Appl. No. 10/808,251 Response to Office Action Mailed November 28, 2006

REMARKS/ARGUMENTS

Embodiments of the present invention relate to magnetic head structures. As described in connection with the particular embodiment of FIG. 1 (reproduced in part below):

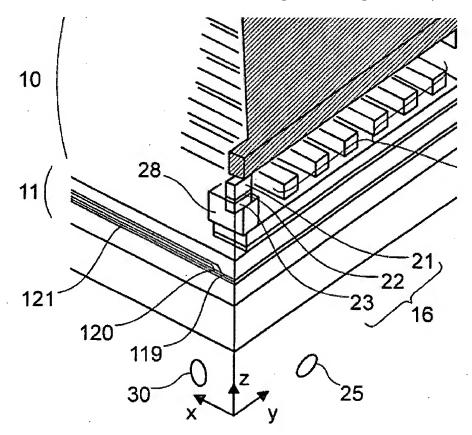
the magnetic head features the edge of the upper core edge layer (21) and the edge of the lower core edge layer (23) aligned on a side opposite to the air bearing surface as well as on the air bearing surface (30) side. Such alignment can result from successive formation of the layers utilizing a single mask. (See ¶[0065])

Pending independent claims 1, 5, 13, and 16 recite this alignment characteristic.
